Subject: Evaluation of Candidate MgO Materials for use as Backfill at WIPP

subject: Evaluation of Candidate MgO Materials for use as Backfill at WIPP

Attachment 1 - Engineering Change Proposal

Figure 3.1

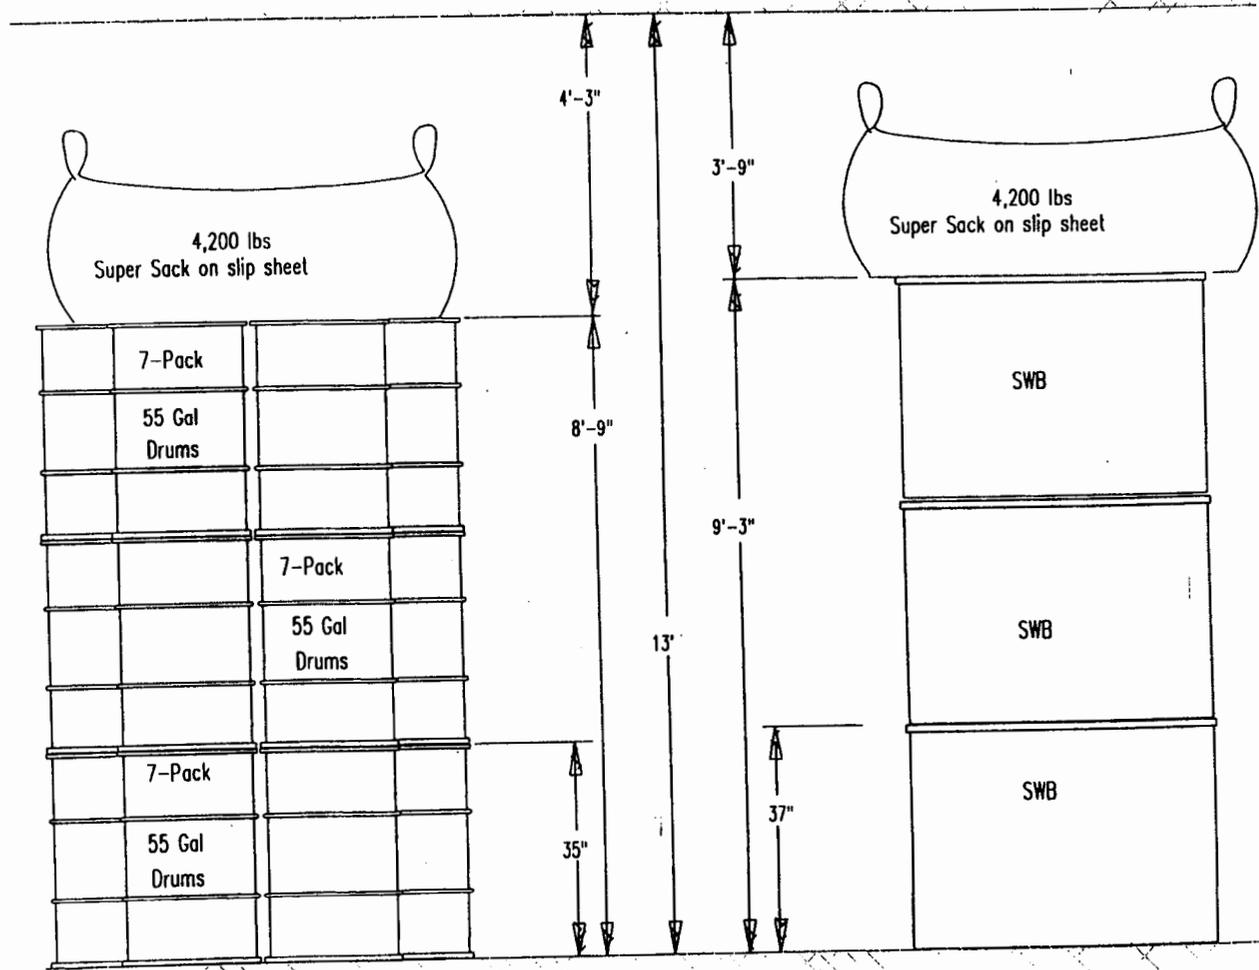
3.2.1 Supplier filled super sacks will be handled during transportation to the WIPP, at receipt and during material handling operations on support sheets. Refer to Figure 3.1 for the emplaced position of the super sack.

3.4.1 The supplier shall provide backfill containers which comply with the requirements for super sacks as outlined in Sections 3.3.2 above. The super sack shall be filled with ~~4,100~~ 4,200 ± 50 pounds of backfill material as specified in Section 3.3.1.5 above.
